# Bramford to Twinstead Reinforcement

Document 8.5.9 (B): Technical Note on Noise Levels at Hintlesham Woods

Final Issue B  
February 2024

<u>Date</u>	<u>Issue</u>	<u>Status</u>	<u>Description / Changes</u>
<u>October 2023</u>	<u>A</u>	<u>Final</u>	<u>First version entered into Examination at Deadline 3.</u>
<u>February 2024</u>	<u>B</u>	<u>Final</u>	<u>Updated version for Deadline 9.</u>

TITLE: **Figure 7.1.8  
Proposed Works around  
Hintlesham Woods**

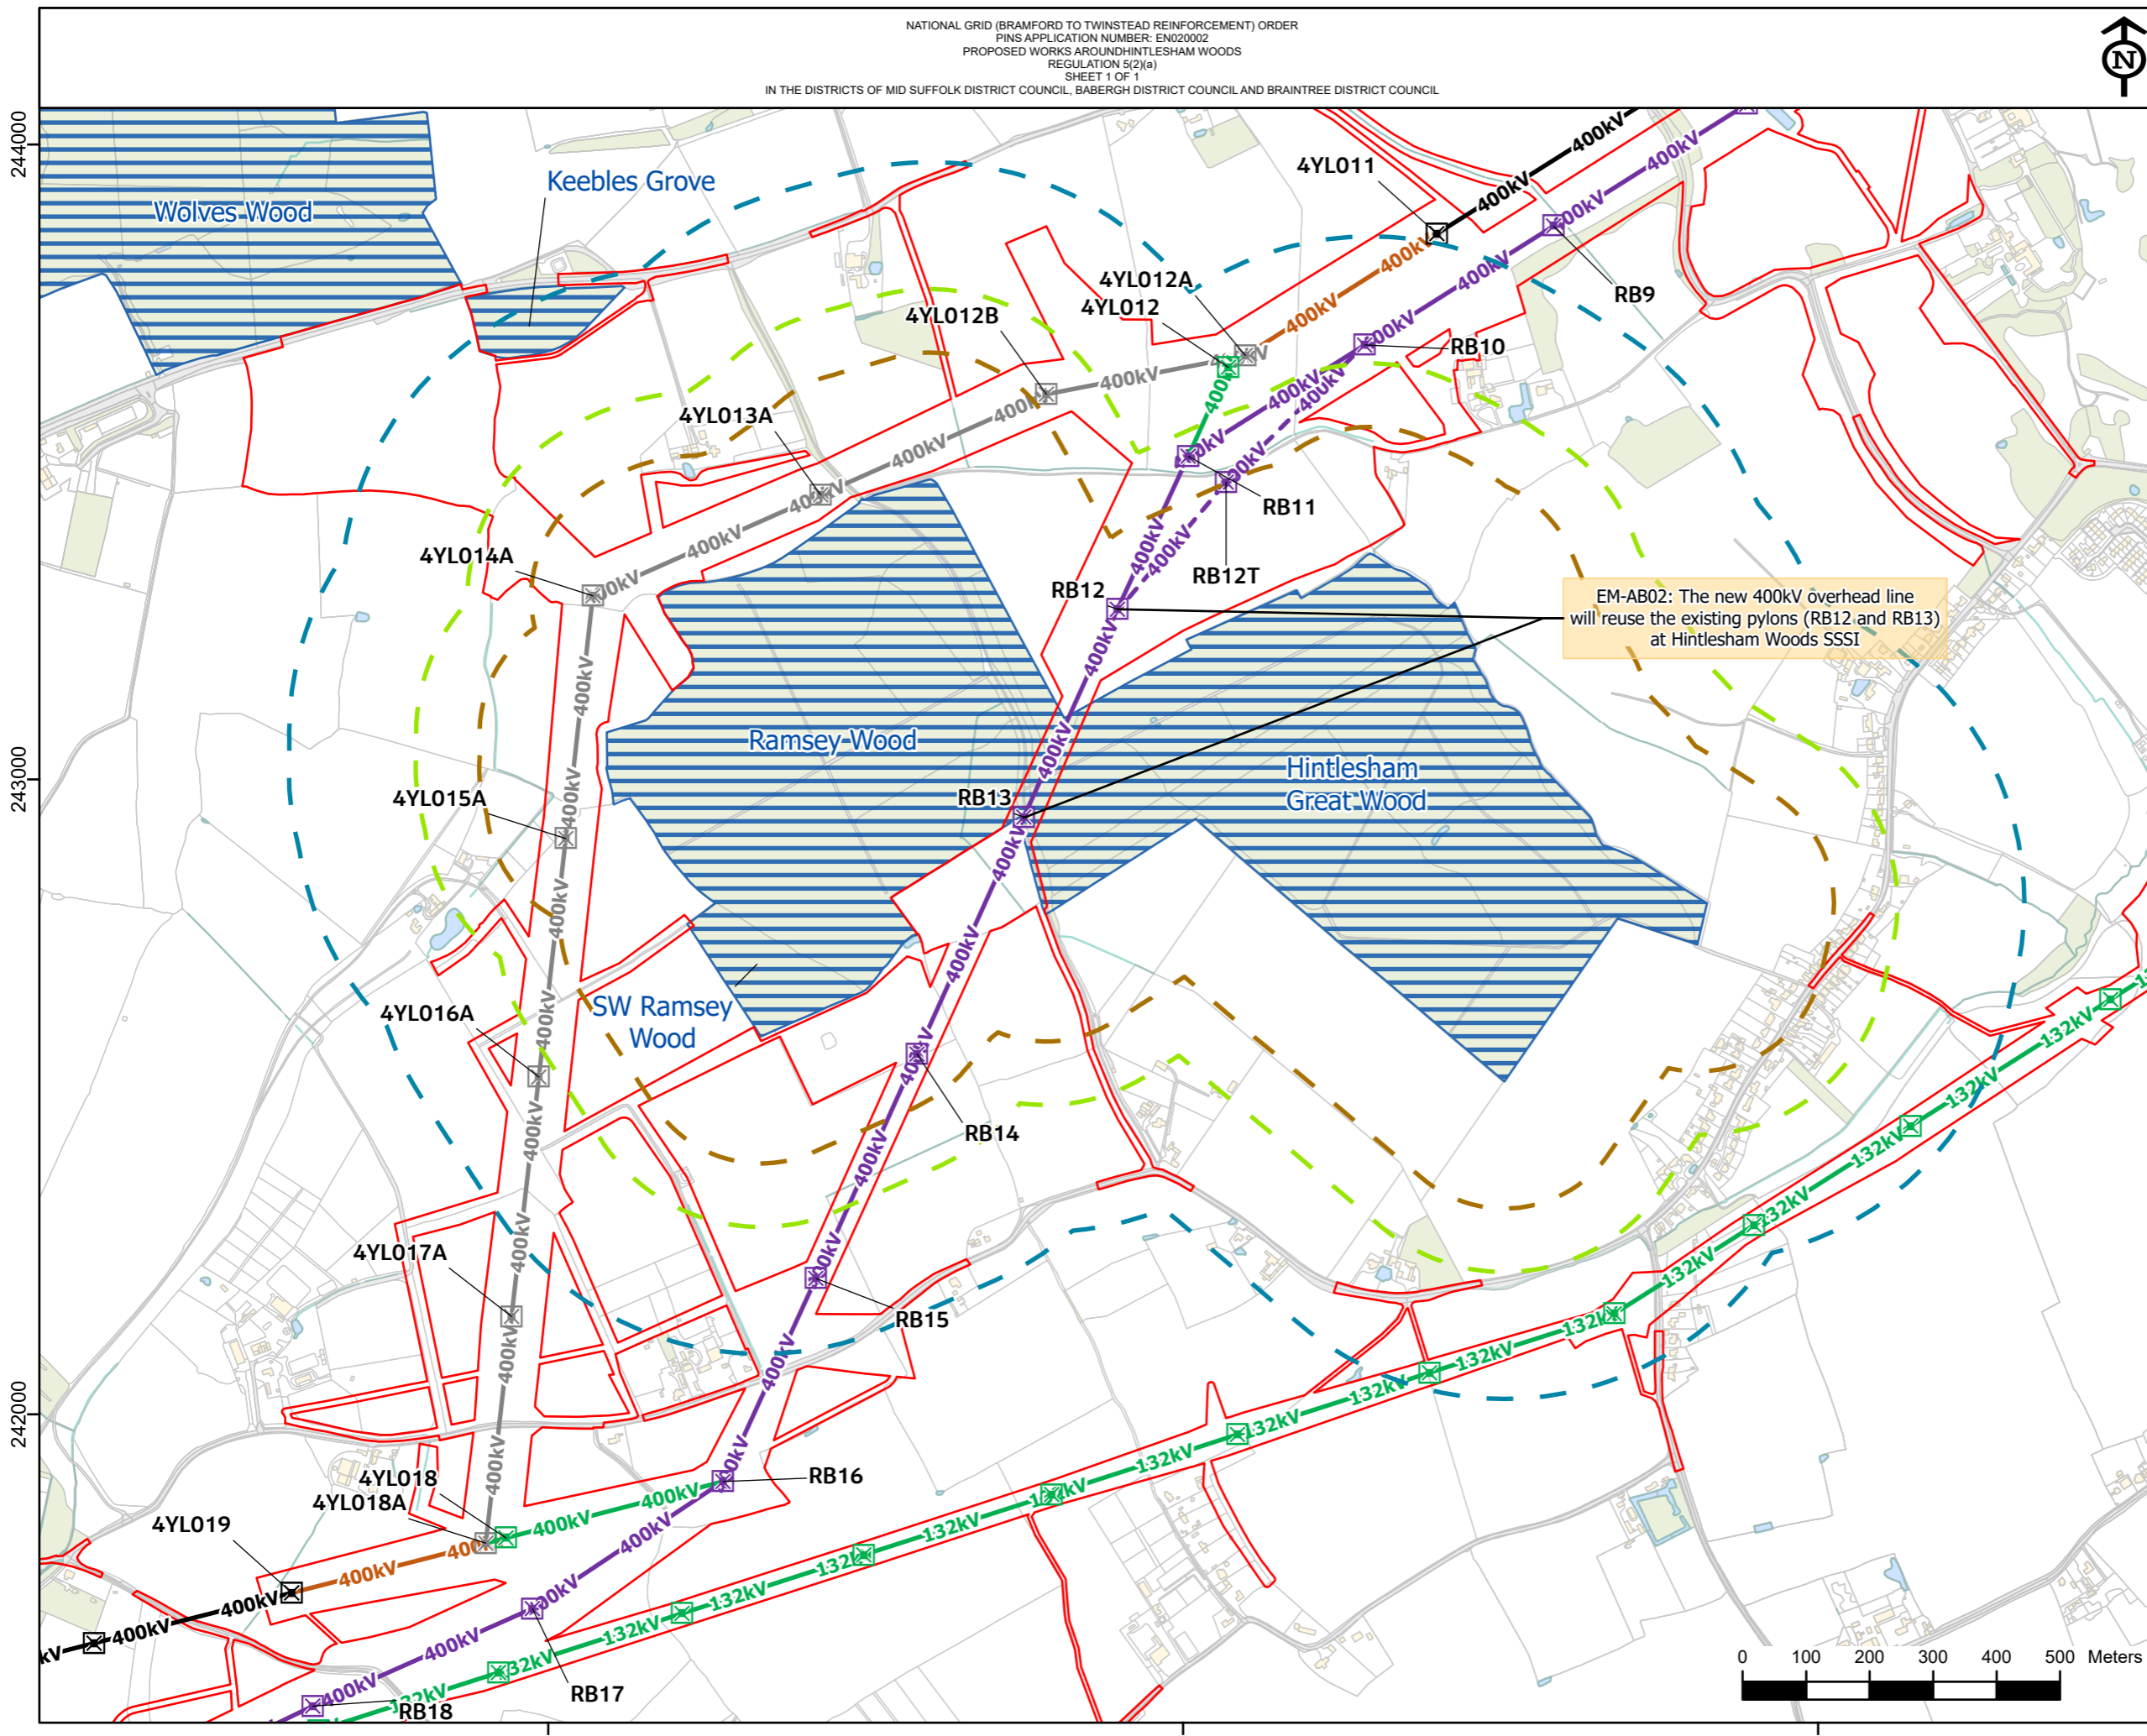
3.1.2 Pylon RB11 (located at NGR 607007, 243509) is now considered to be the closest pylon to the SSSI boundary that relies on an electrical outage for construction and therefore may need to be constructed during bird breeding season. RB11 is approximately 260m away from Hintlesham Woods SSSI at the closest point and 360m from the north-eastern edge of Ramsey Wood. This pylon (RB11) is shown on ES Figure 7.1.8 [APP-149], which is reproduced in Appendix A of this Technical Note.

3.2.1 Existing pylon 4YL012 would be removed as part of the works. This would involve dismantling of the pylon and associated conducted and fittings, cutting up of the pylon structure for removal from site and removal of the concrete foundation. Pylon 4YLA012 is located at NGR 607071, 243649 approximately 360m away from Hintlesham Woods SSSI at the closest point and 490m from the north-eastern edge of Ramsey Wood. This pylon is shown on ES Figure 7.1.8 [APP-149], which is reproduced in Appendix A of this Technical Note.

2.2.33.3.3 Pulling and tensioning would be required on the section close to northern circuit to the north of Hintlesham Woods SSSI pulling and also on the circuit through the woods. Pulling and tensioning is proposed at pylons RB11 RB10 (NGR 607008, 243509 607286, 243684) and RB16 (NGR 606275, 241894). Pylon RB11 RB10 is located approximately 260m 330m from Hintlesham Woods SSSI to the north at the closest point and 360m 700m away from the eastern edge of the SSSI which contains records of the presence of breeding nightingale. Pylon RB16 is located south-west of Hintlesham Woods SSSI, approximately 700m from the closest edge of the woods. Pylon RB11 RB10 and RB16 are shown on ES Figure 7.1.8 [APP-149], which is reproduced in Appendix A for ease of reference.
